PERMIT
SEWAGE DISPOSAL SYSTEM
HOWARD COUNTY HEALTH DEPARTMENT
BUREAU OF ENVIRONMENTAL HEALTH
410-313-2640

P 514988-F
A 58993-D
ISSUE DATE 3/19/2001
APPROVAL DATE 5/1/01

ADDRESS 13785 Burntwoods Road, Glenelg, MD 21737 PHONE 301-854-6172
SUBDIVISION Cattail Ridge LOT NUMBER 4 ADDRESS 15004 Rolling Hills Drive
PROPERTY OWNER Syndacom Property PROPERTY OWNER'S ADDRESS 8808 Center Park Drive
SEPTIC TANK CAPACITY 1250 GALLONS Columbia, MD 21045
PUMP CHAMBER CAPACITY N/A GALLONS
NUMBER OF BEDROOMS 4
SQUARE FEET PER BEDROOM 210
LINEAR FEET OF TRENCH REQUIRED ~~230~~ 210'

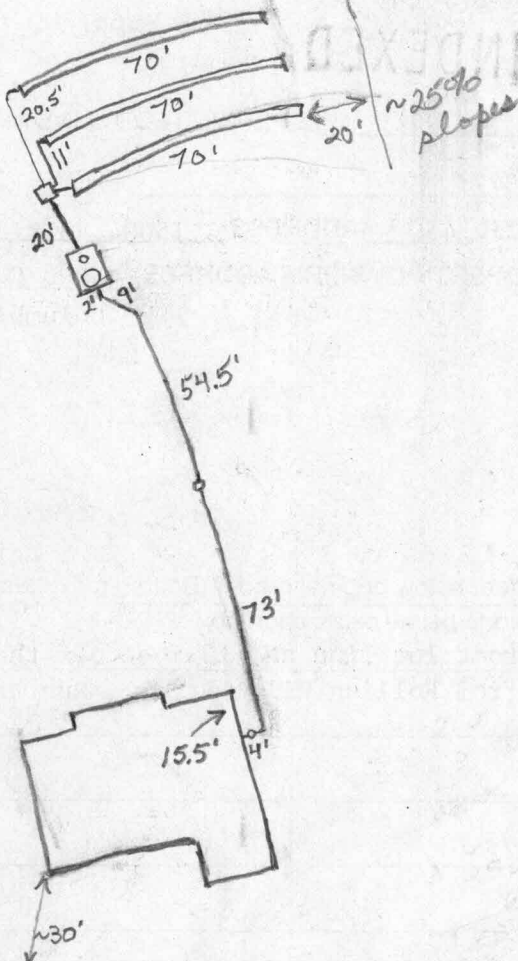
4/30/01 To install 3-70' trenches. Keep 25' from dropoff. Inlet 3', bottom 7', trenches 2' wide. (BB)

INSPECTION COMMENTS: 5/1/01 System satisfactory. O.K. to cover. Because trenches shortened closest trench is around 20' from 25% slope. With future repairs trenches may be put closer to slope as it diminishes the further downhill you go. (BB)
